Re:- Plot No. 20, C.L.10, Civil Lines Cr.
.....

PLAN SHOWING PROPOSED ADDITIONS & ALTERATIONS & FIRST FLOOR
ON PLOT No 20, SHEET No C/L.10 CIVIL LINES QUARTER
SCALE 8=1

With reference to your application dated 14th February 1941
with a plan for the proposed buildings/additions and alterations on plot
No 20 Survey Sheet No C.L.10, Civil Lines Quarter
I have to request you to comply with the following requirements—

With reference to your application dated _____
with a plan for the proposed buildings/additions and alterations on plot
No. 20 Survey Sheet No. C. L. 10, Civil Lines Quarter,
I have to request you to comply with the following requirements—

SITE PLAN
SCALE 20' = 1"

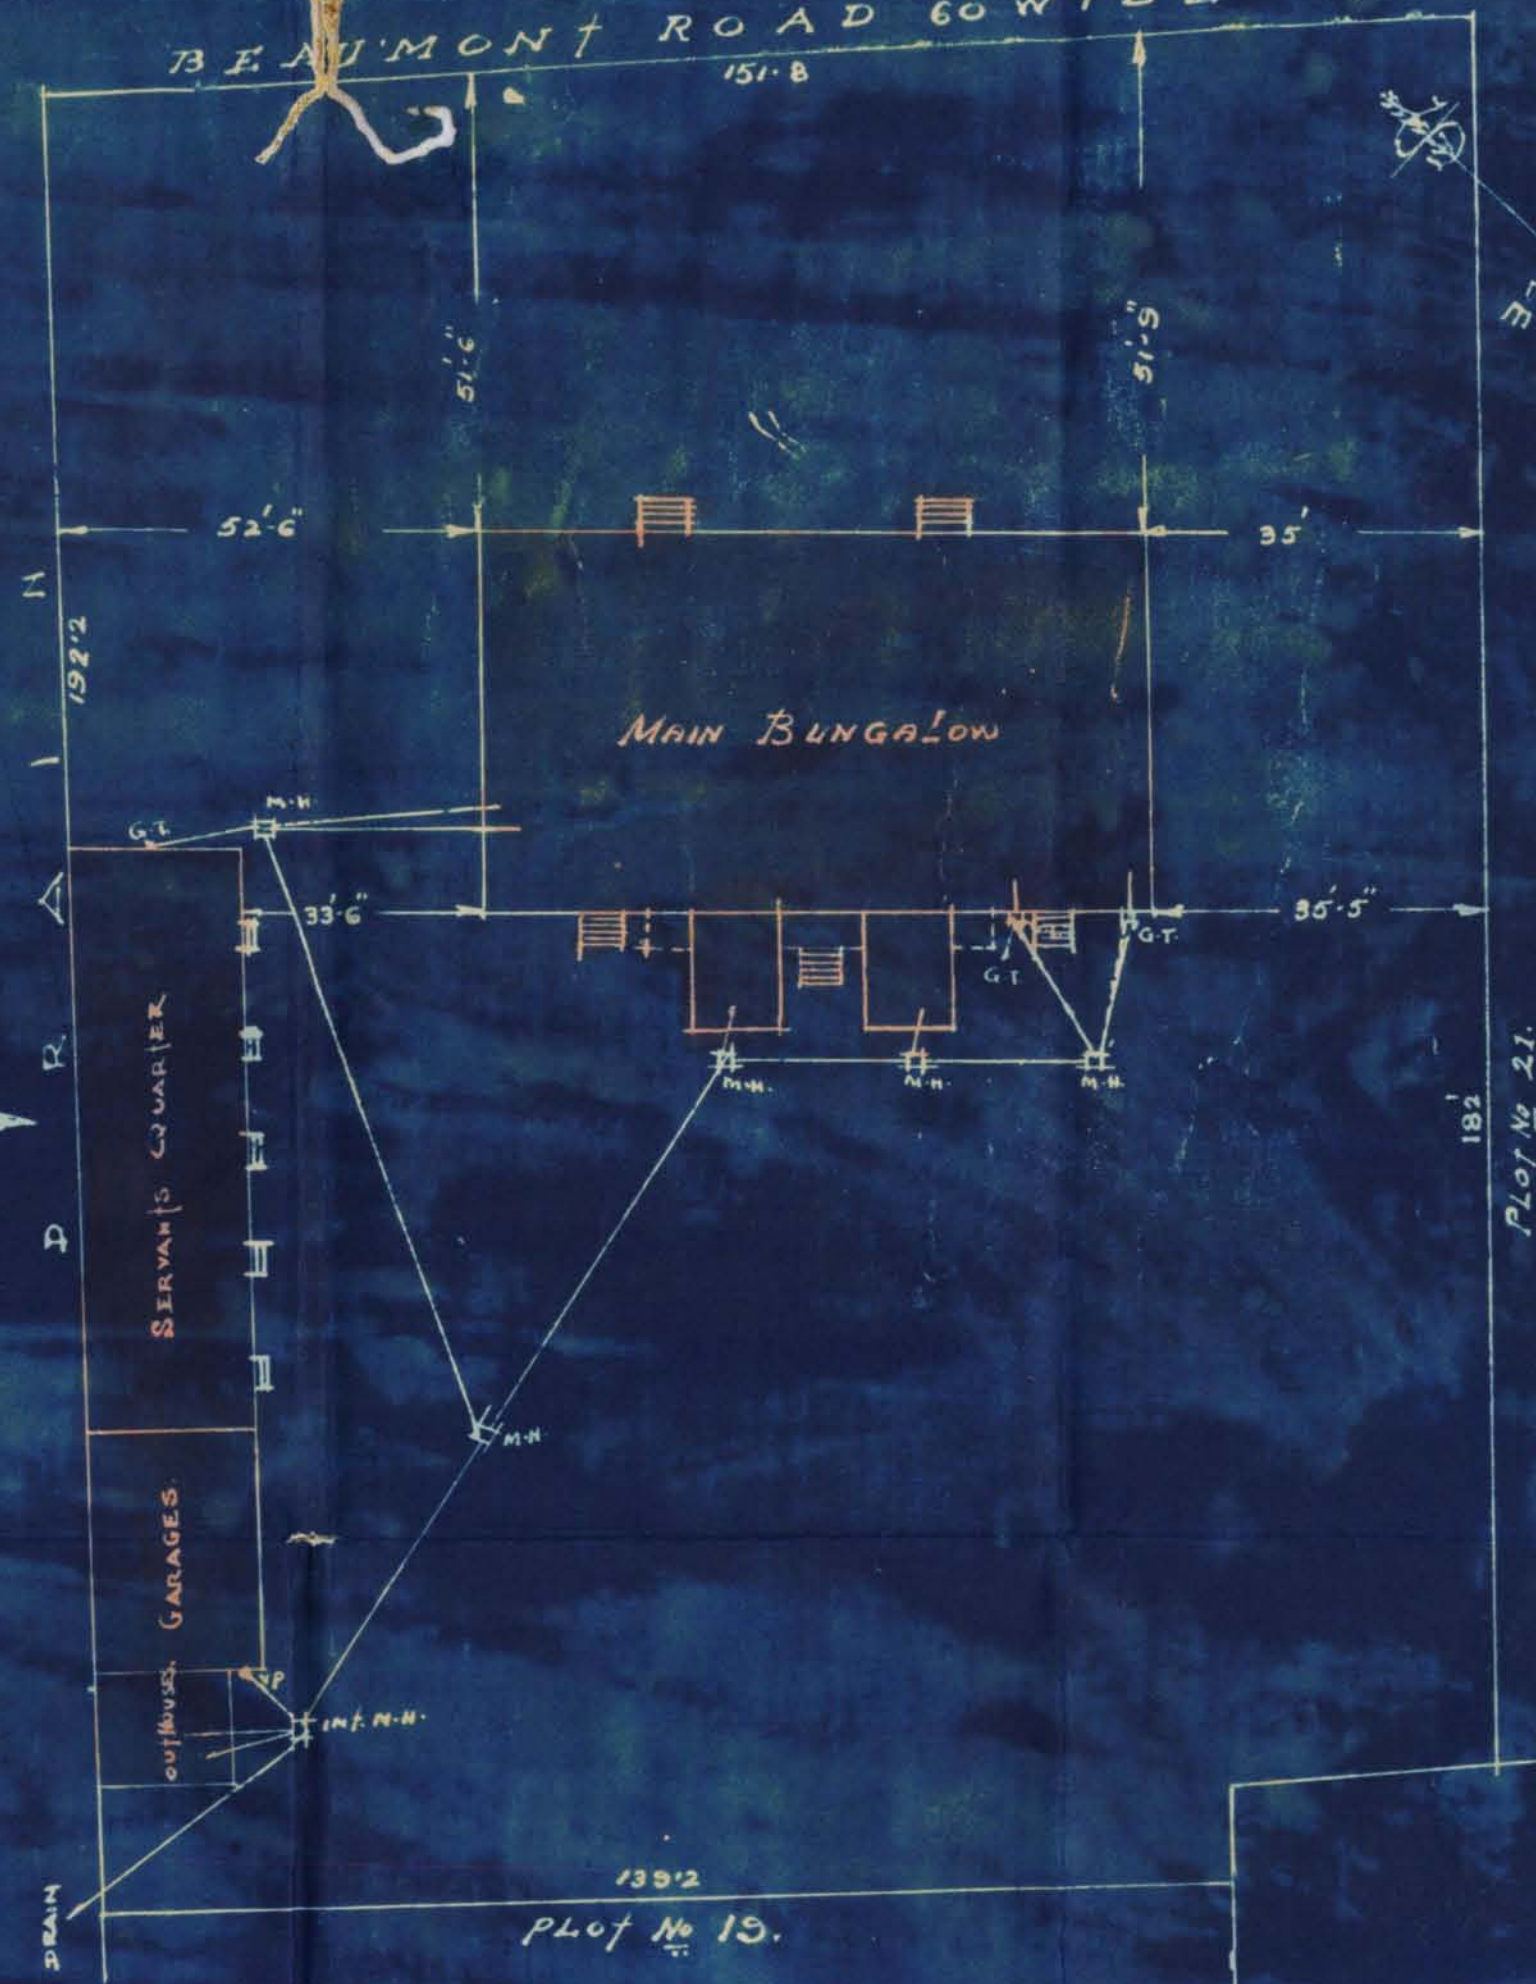
- (1) Unauthorised sinks exist in the rooms which
require to be connected up or removed.

*Unauthorised Sinks exist in
 the rooms which require to
 be connected up or removed*

1. Sinks in outhouses have been coloured yellow and a note made on the plan that they shall be removed. This is done as required by the Health Officer who was seen personally.
2. Building Surveyor will be seen regarding this.

1. Existing sinks in the servants rooms
will be removed.

SITE PLAN
SCALE 20' = 1"

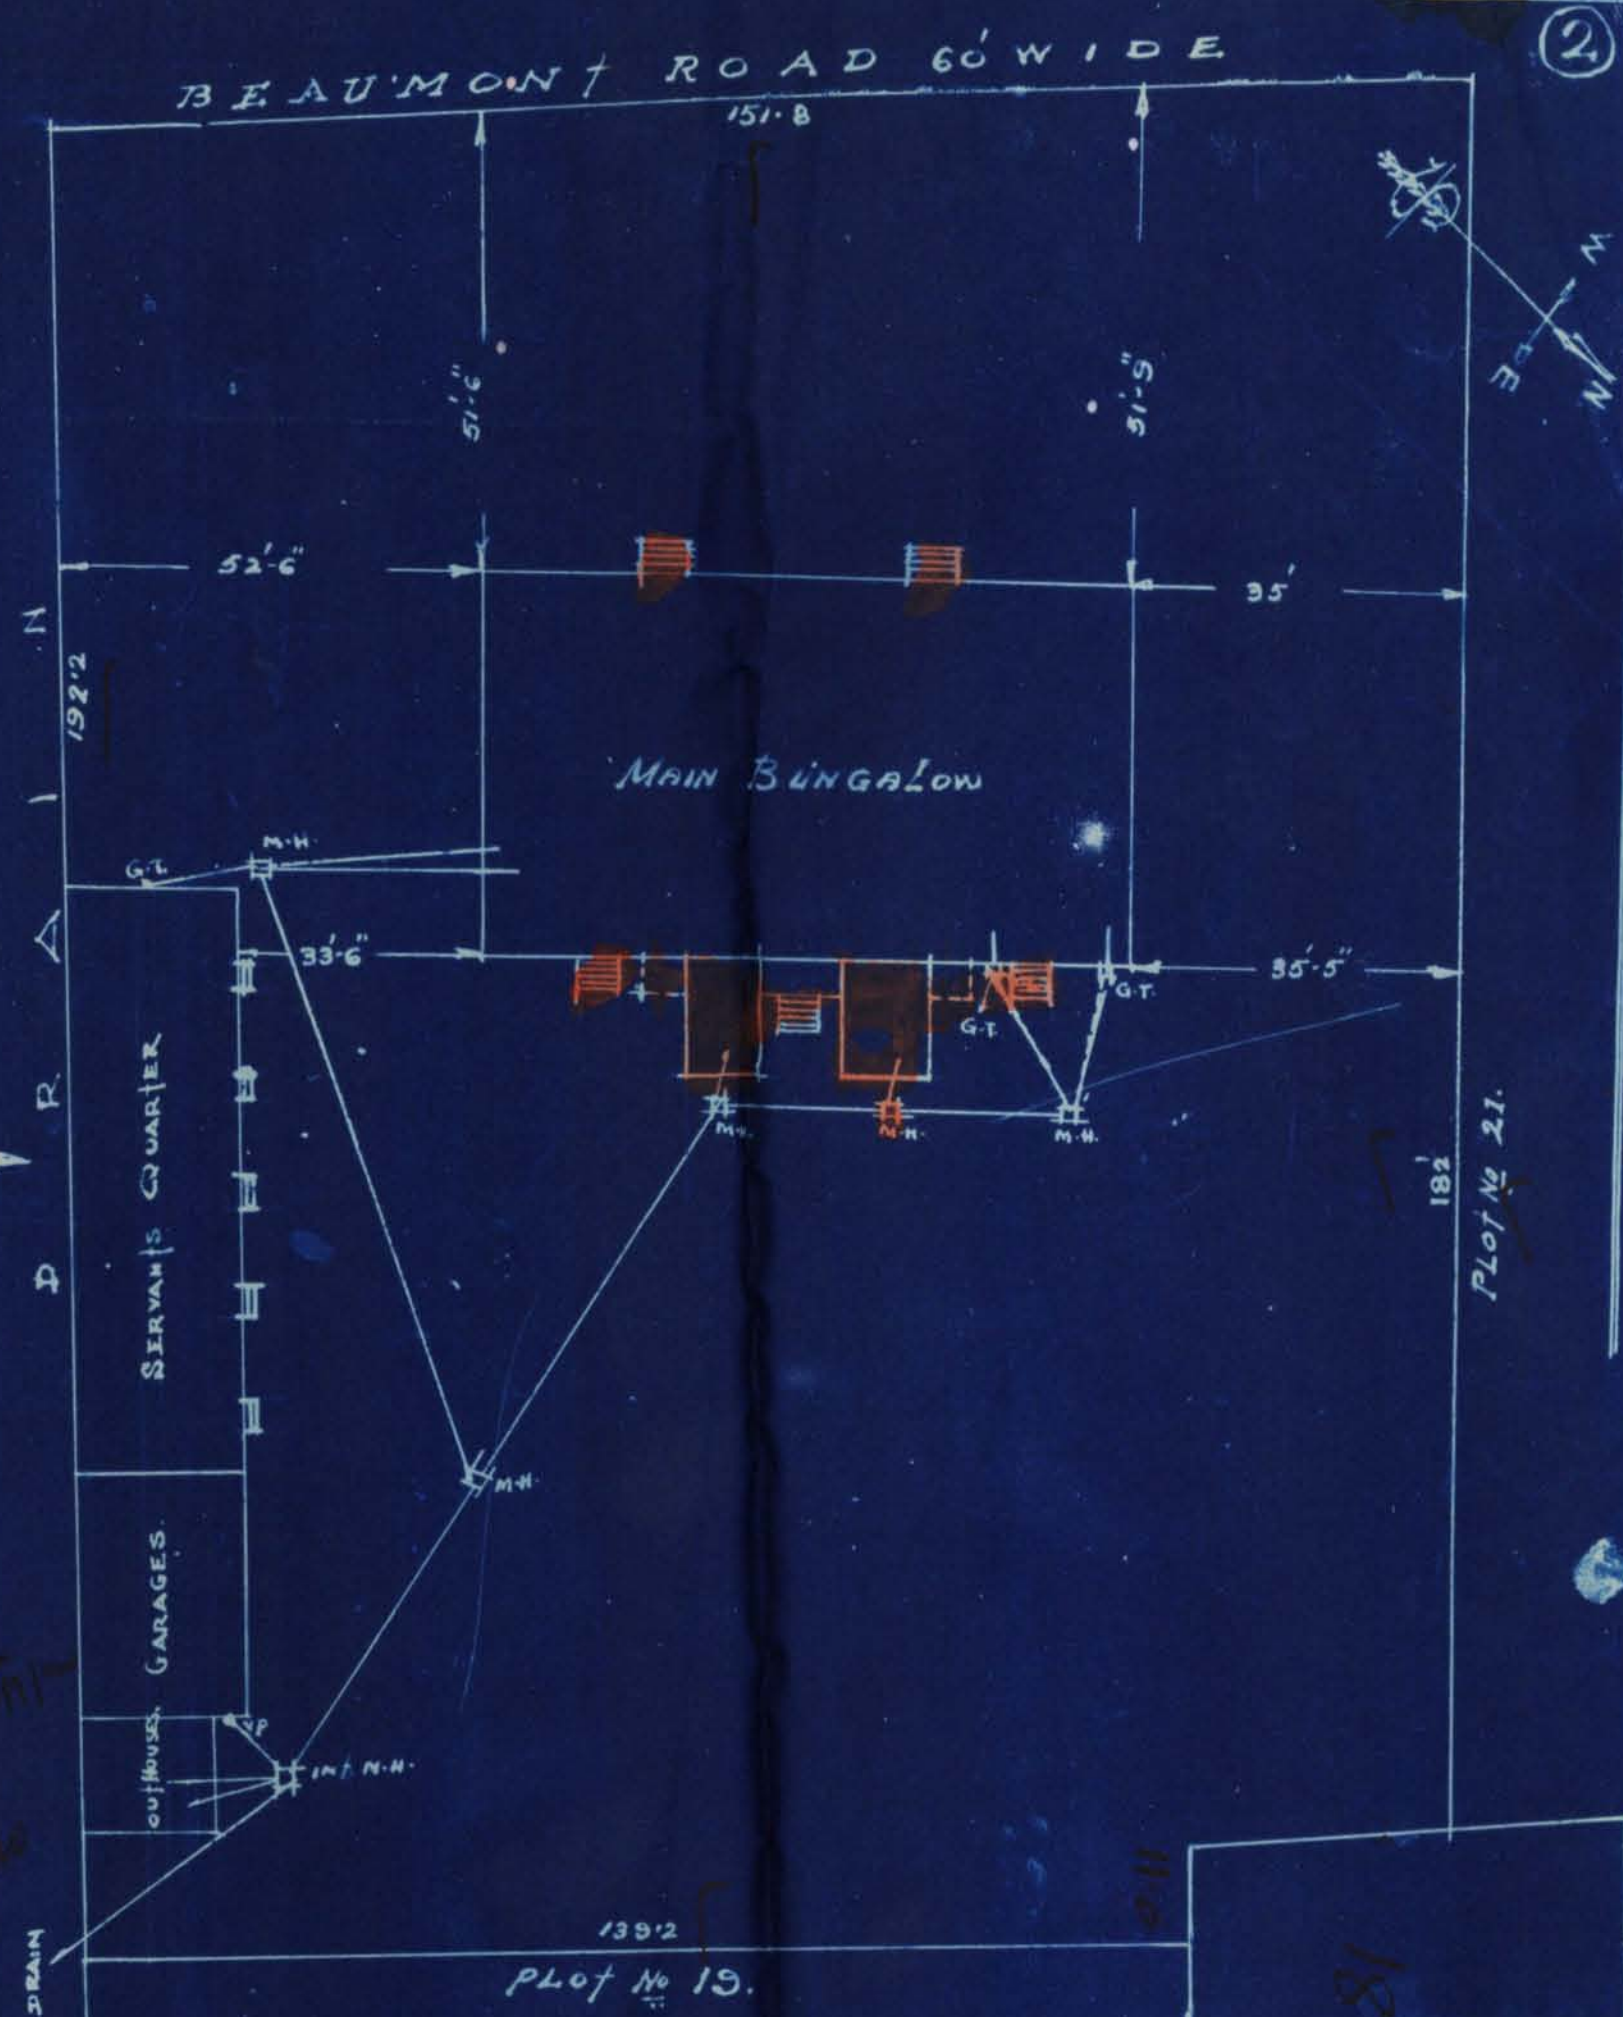
- (1) Outhouses to be connected to the drainage system.

10/12
23-7
Infr. building
to be connected
to the drainage system
23/7

(1).H.O's Objection No.1.: Out-houses

are shown as connected with drainage
line. Siteplan may please be seen .
